Re: BBC's Review of LG&E Energy Corporation Site Assessment Report for Proposed
Trimble County Unit Number 2 in Trimble County, Kentucky

Review and Evaluation of
Trimble County Unit 2
Site Assessment Report

Review and Evaluation of Trimble County Unit 2 Site Assessment Report

Exhibit C-4.
Proposed New Transmission Line for TC2

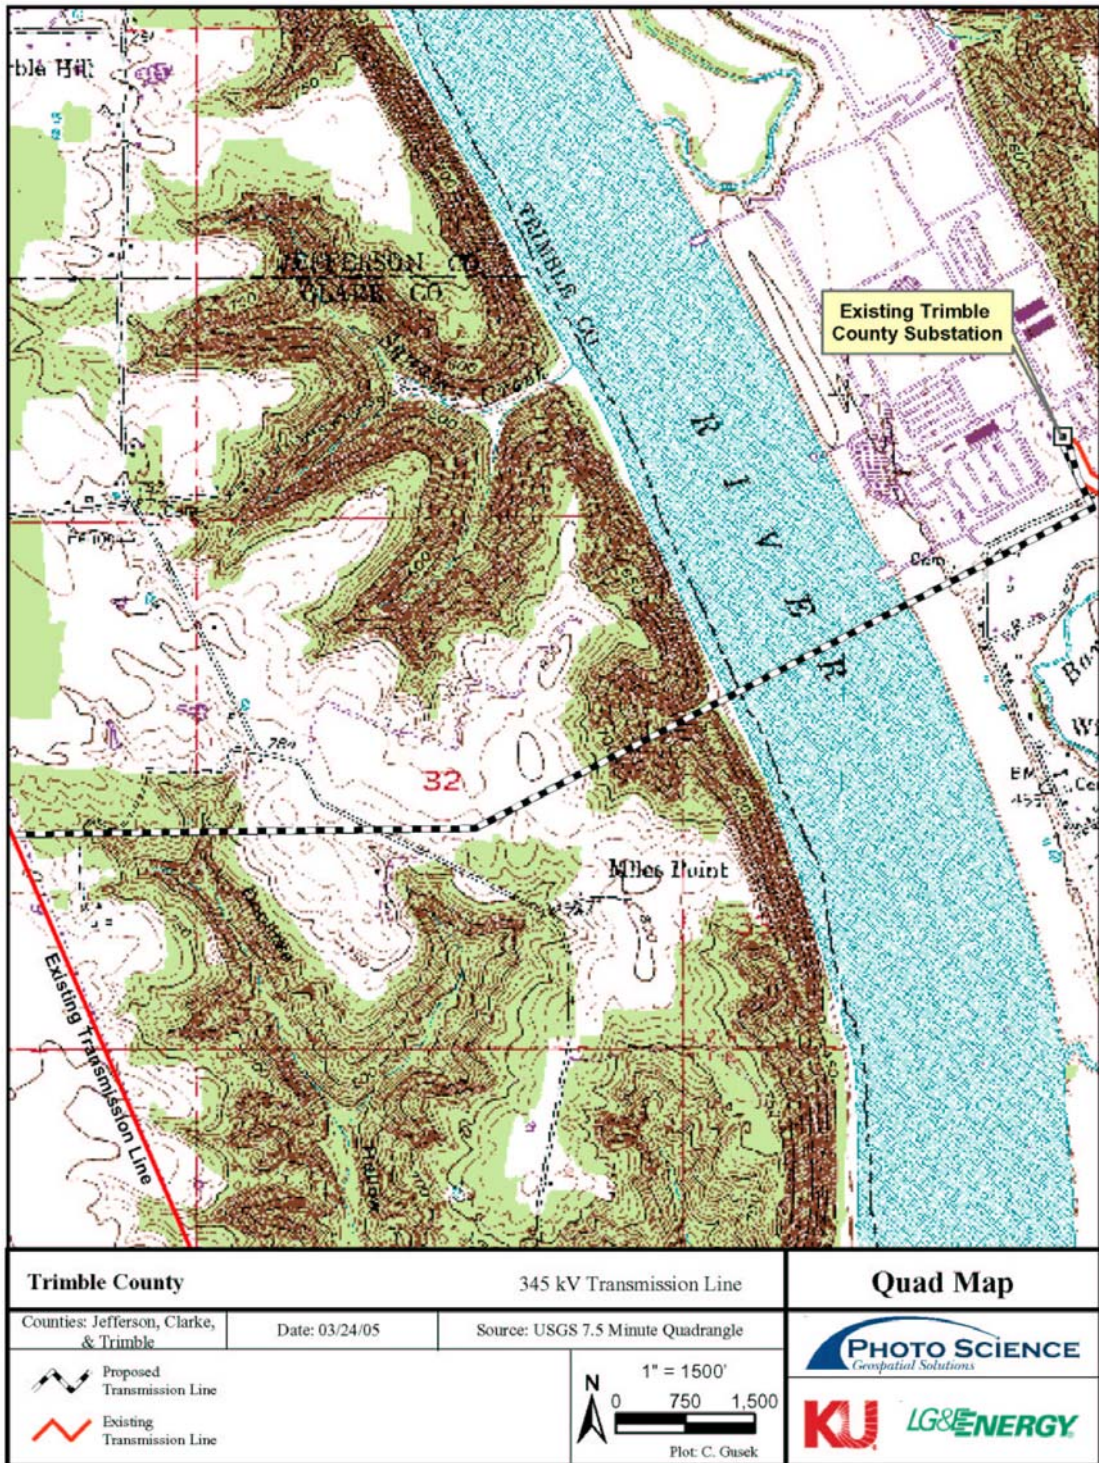
Location of buildings, transmission lines and other structures. The applicant's SAR included two drawings, Figure 2-1 (page 7) and Figure 2-2 (page 9), that depict existing structures and facilities at the Trimble County Station and proposed new structures for TC2, respectively. The location of proposed transmission lines were not shown on the figures provided in the SAR.

Location of buildings, transmission lines and other structures. In response to BBC's initial information request, LG&E provided a figure showing the route of existing and proposed transmission lines as they depart the existing switchyard at the southeast corner of the Trimble County Station and leave the site. During the site visit, LG&E provided an additional map, labeled "Trimble County – PSI Interconnection 345KV Line" that shows the route of the proposed new transmission line from the site to an interconnection with an existing 345 KV line located a couple of miles across the Ohio River in Indiana. This route would cross less than one mile of lands located in Kentucky before crossing the river. The route passes through the small area of agricultural land separating the station from Wisers Landing to the south.¹⁷
